August 12, 2010

Request for Antenna change – PCB layout change V2 to V3 (2010 Wireless Drum Controller – XBOX 360)

Blue = V3 Yellow = V2

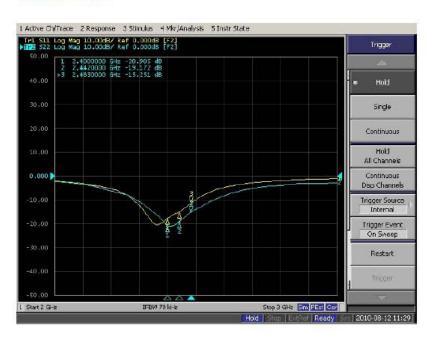
Antenna centering improvement is made by slight shortening of antennas tuned length. No impact on radiated power or emissions was detected in subsequent testing.
